NSW Planning, Industry & Environment Environmental Impact Statement Kellyville

Station Precinct Concept Proposal (SSD-10343)

The Secretary
NSW Planning, Industry & Environment

Proposed Endeavour Energy 2 x 1500kVA Indoor Chamber Substation

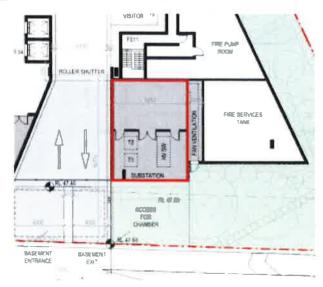
A current example of this is The Hills Shire Council Development Application 483/2020/JP at Civic Way, ROUSE HILL NSW 2155 (Lot 129 DP 280036) for 'Mixed use development comprising 375 residential apartments, commercial/retail tenancies, stratum subdivision and associated works'. Whilst adequate area is available on site to accommodate padmount substations, the applicant is utilising a single indoor substation with multiple transformers (also replacing a single existing padmount substation located on the site) which is shown in the following extract of the Services DA Report Electrical, Mechanical & Level 3 Services and elevation from the Architectural Plans.

At present, the proposal is to install a new 2 x 1500kVA transformer indoor surface chamber substation located in northeast corner of the site on Basement Level 1 to provide electrical supply to the development. As the site grades to the north, Basement Level 1 level is at street level providing standard Endeavour Energy access directly from Civic Way as shown in the figure below.

Although Endeavour Energy's preference remains for the use of padmount substations, their incorporation into medium and high residential developments is often not considered in the design phase. As shown in the following examples, this may leave limited opportunity for landscaping or screening or adoption of prudent avoidance principles. Endeavour Energy is urging applicants /customers to engage with an Electrical Consultant prior to submitting plans to development applications in order to assess and incorporate any required electricity infrastructure. This allows consideration to be given to its impact on the other aspects of the proposed development and possibly avoid the need to seek modifications of an approved development. Having regard to the built form design principles for the Precinct, the utilisation of indoor substations where appropriate may help ensure quality urban outcomes across the Precinct.
